IEEE P802.15
Wireless Personal Area Networks

Project	IEEE P802.15 Working Group for Wireless Personal Area Networks (WPANs)	
Title	TG3 LB19 comment resolution	
Date Submitted	[24 September, 2002]	
Source	[James P. K. Gilb] [Apparent Technologies] [9921 Carmel Mountain Rd. #247, San Diego, CA 92129]	Voice: [858-538-3903] Fax: [858-538-3903] E-mail: [gilb@ieee.org]
Re:	[]	
Abstract	[This document is a record of comment resolutions for LB19.]	
Purpose	[To provide a record of the comment resolution for LB19.]	
Notice	This document has been prepared to assist the IEEE P802.15. It is offered as a basis for discussion and is not binding on the contributing individual(s) or organization(s). The material in this document is subject to change in form and content after further study. The contributor(s) reserve(s) the right to add, amend or withdraw material contained herein.	
Release	The contributor acknowledges and accepts that this contribution becomes the property of IEEE and may be made publicly available by P802.15.

Figure 3—PNC handover MSC

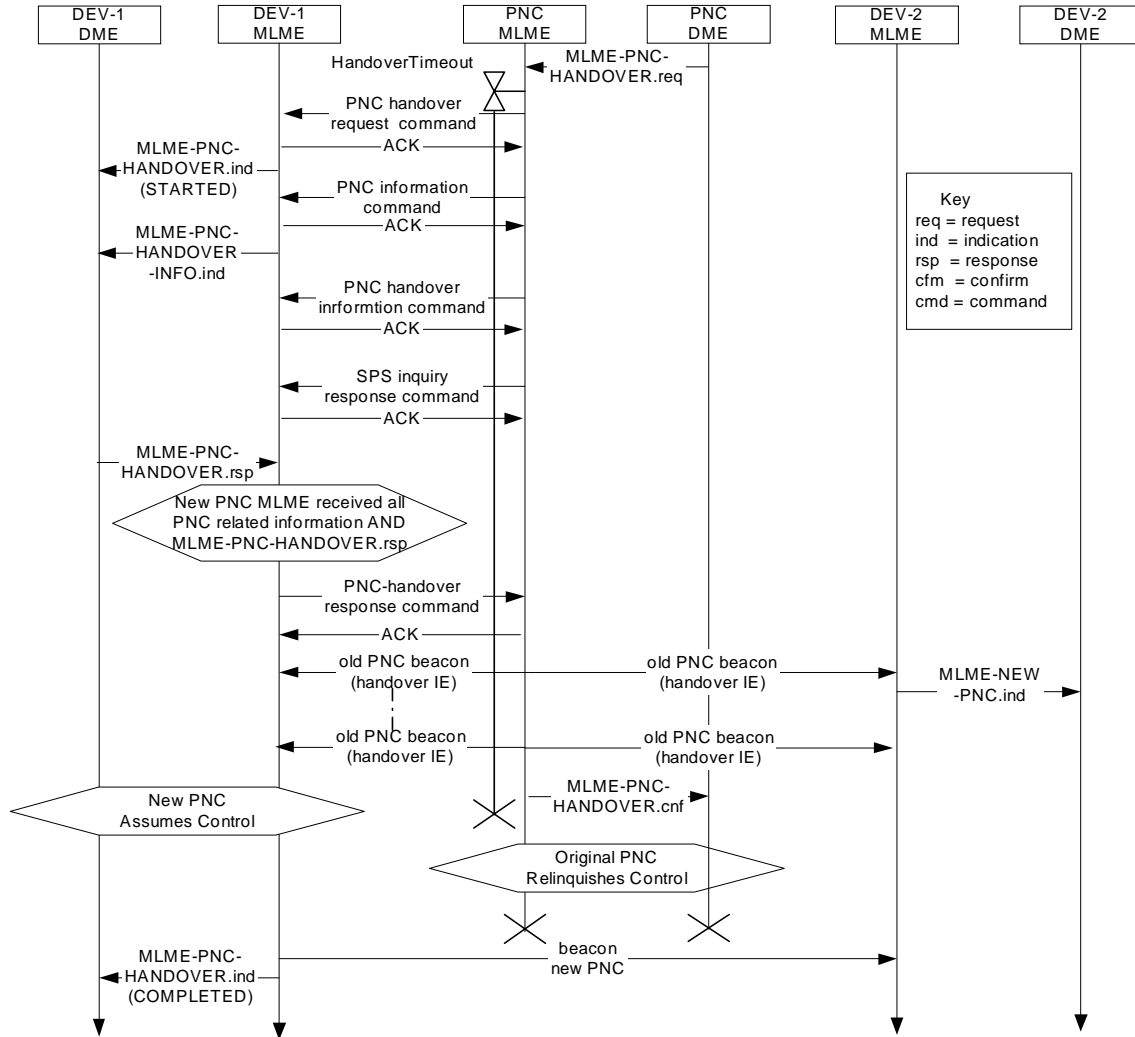
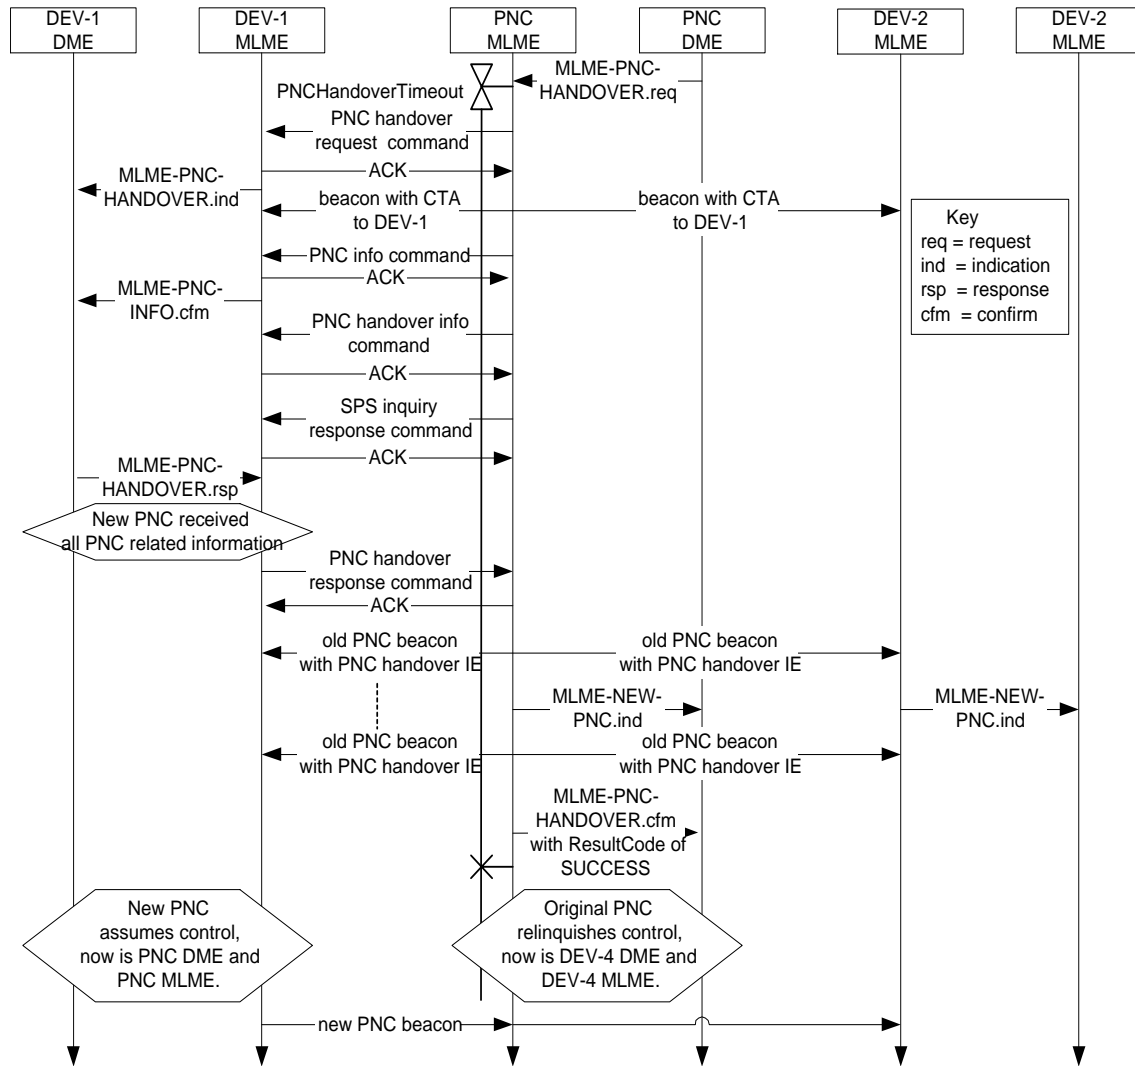
269 (Heberling, TR) - [PNCHndOvr] Some errors in text remain or were introduced after LB17.MSC in Figure 91 is also wrong./KO Text changes for 8.2.3 and ne MSC for Figure 91 are all collected in:02276r7P802-15_TG3-commentsD11_KO.doc, Resolution [03]. **Suggest accept in principle**, “The MSC will be modified as indicated in the resolutions of CID 58 and 232. Make the following text changes: In 6.3.13.4, page 59, line 45, change ‘This primitive informs the originating DME its request for information from the PNC is complete.’ to be ‘This primitive informs the DME that the MLME has received a PNC information command, {xref 7.5.4.2}.’ In 7.5.3.1, page 138, line 20 ‘the number of information records to be transferred using the PNC information command frame(s).’ to be ‘the number of DEV information records, {xref PNC handover info command}, that will be transfered from the old PNC to the new PNC.’ In 8.2.3 PNC Handover, delete page 156, line 8-9, redundant, same text in paragraph below. Add to page 156, line 19, ‘The PNC handover information command shall not be sent if the PNC has indicated in the PNC handover request command that it does not have any CTRBs to transfer.

463 (Gubbi, TR) - Figure-91 is a well done job, but the text needs to supplement some info that can not be expressed in the figure, which is incomplete in the current update to this para. It should be mentioned that these commands shall be sent by PNC even if there is no information present that fits into those commands so that the rx-DEV knows the exact end of the transaction. For example, what if there are no DEVs in power save mode. Still the SPS-inquiry-response-command shall be sent by PNC. It should be mentioned that the three commands in Figure-91 (PNC-info-command, PNC-handover-info-command and SPS-inquiry-response-cmd) shall be sent by PNC even if there is no information present that fits into those commands so that the rx-DEV knows the exact end of the transaction. For example, what if there are no DEVs in power save mode. Still the SPS-inquiry-response-command shall be sent by PNC. **Suggest accept in principle,** "Rather than send the empty commands, the PNC handover request will contain the number of CTRBs and SPS sets that will be transferred. If the number of items is zero, then the old PNC shall not send the command and the new PNC will not expect to receive it. It is not possible for the number of DEVs to be less than 2 (i.e. the old PNC and the new PNC), so the PNC information command will always be sent. This is documented in the resolution of CID 269."

The SPS inquiry response command shall not be sent if the PNC has indicated in the PNC handover request command that it doesn’t have any SPS sets to transfer.’

Add to page 156, line 35, ‘The new PNC shall broadcast its first beacon at the time the beacon would have been sent by the old PNC. This time may vary from the actual time due to clock inaccuracies of old and new PNCs. The new PNC shall start sending beacons with the beacon number counter set to one more than the beacon number of the last beacon that will be sent by the old PNC.’

Add page 156, line 40ff, ‘The PNC shall ensure that the beacon countdown includes at least one system wake beacon and at least aMaxLostBeacons beacons following that system wake beacon. The only exception to this requirement is if the PNC will be shutting down and does not have enough time to to wait for the next system wake beacon to complete the handover process. {Ed. note: This line may be moved to a new 8.1.1 that describes all beacon announcements.’}
